TITLE: SPECIAL PERMIT NO. 1901, VAVIK RIDGE COMMUNITY UNIT PLAN, requested by Brian D. Carstens and Associates, for 22 dwelling units of elderly housing, including 100 percent density bonus, with requests to waive sidewalk design standards; front, rear and side yard setbacks; and the 3-to-1 depth-to-width ratio, on property generally located at South 56th Street and Elkcrest Dr.

LINCOLN CITY/LANCASTER COUNTY PLANNING STAFF REPORT

Vavik Ridge CUP

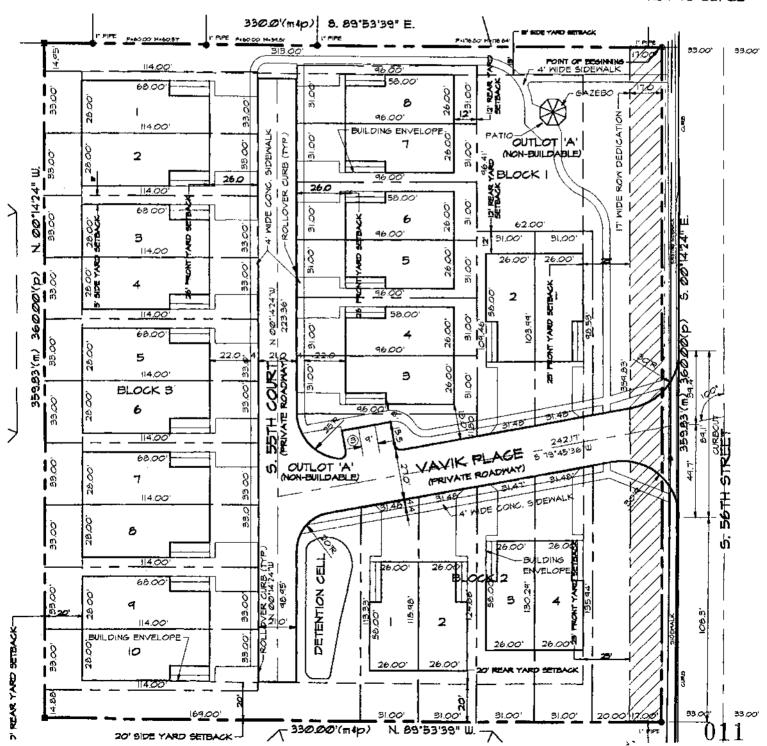
- 1.1 Revise the site plan to show:
 - 1.1.1 Note 15 from the site plan adjusted as per Planning Commission approval.
 - 1.1.2 Additional note on the site plan stating that the 3 parking stalls shall be screen at the request of the property owner of Lot 3, Block 1.

- 1.1.3 Additional note on the site plan stating that decks shall be prohibited on the rear of the units on Lots 3, 4, 5, Block 1.
 - 1.1.4 Sheet 1 of 5 instead of 1 of 6.

- 1.1.5 Street trees on the private streets planted at least 5' from the back of the sidewalk.
 - 1.1.6 Additional note on the landscape plan stating, "the street trees on S. 56th Street shall be planted on private property."
